BREVARD COUNTY
FACILITIES ENGINEERING & CONSTRUCTION
AUTHORIZATION TO INITIATE WORK

AUTH/CHANGE ORDER NO: 04

PROJECT TITLE: Space View Park Improvements

Prime Contract Potential Change Order #004: DOCK PILES SOUTH PIER

RFI #16: SOUTH DOCK PILE SETTling

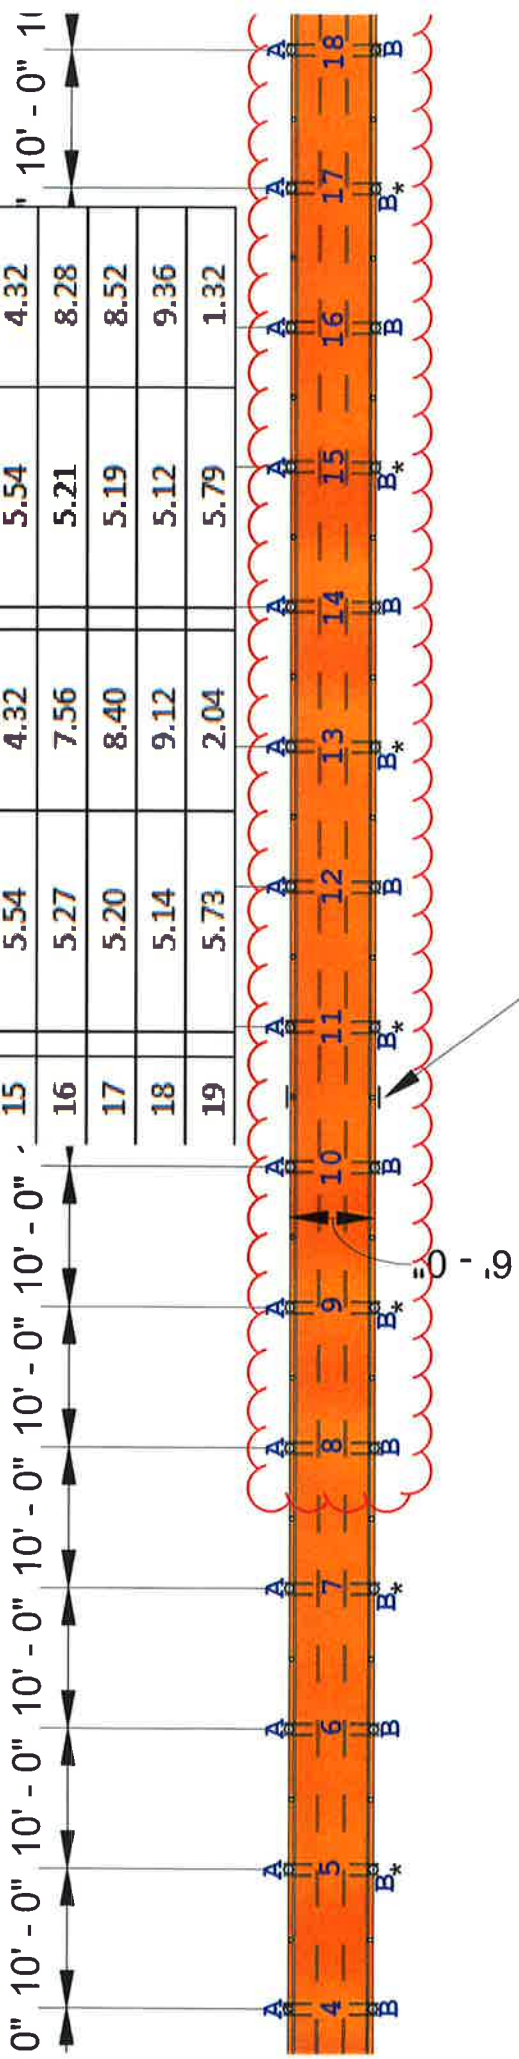
| Question | <p>Question from Mark Lucas RUSH Construction, Inc. on Friday, Mar 12, 2021 at 01:28 PM EST</p> <p>As per our telephone discussion, during construction of the south dock walkway March 9, 2021 we discovered some of the piles had sunk slightly from their installed elevation. On March 10, 2021 we discovered they had sunk significantly more. On March 11, 2021 we made some adjustments and raised the framing back to design elevation. But we are still noticing some settling this day. The problem appears to be limited to the south dock east end of walkway span. See attached drawing which identifies the pile locations, lengths and as-built deck elevations taken on March 12, 2021. Note: The actual pile embedment depths exceed the design requirement of 6' of embedment and in some places is over double the requirement. See also, attached photo of dock taken on March 11, 2021. Please review and advise what course of action we should take.</p> <p>Attachments RFI 16 attachment.pdf, RFI 16 photo attachment.pdf</p> |

| Official Response | <p>Response from David Tom Construction Engineering Group on Monday, Mar 15, 2021 at 02:23 PM EDT</p> <p>I spoke to Ardaman and we think that 3-borings located adjacent to the area of the pier that has dropped at depths between 30'-40' should be sufficient for Ardaman to make their recommendations.</p> <p>Attachments RFI 16 Borings.pdf</p> |
| Official Response | <p>Response from Michael Butcher Brevard County on Monday, Mar 15, 2021 at 07:44 AM EDT</p> <p>Brevard County has contacted Ardaman and requested geotechnical work or soil borings. BCPR request that the engineer designate what areas and what depths they would like the borings taken. There has been no guarantee from Ardaman on a time frame but hopefully Monday 3/15 we will have a better idea.</p> |
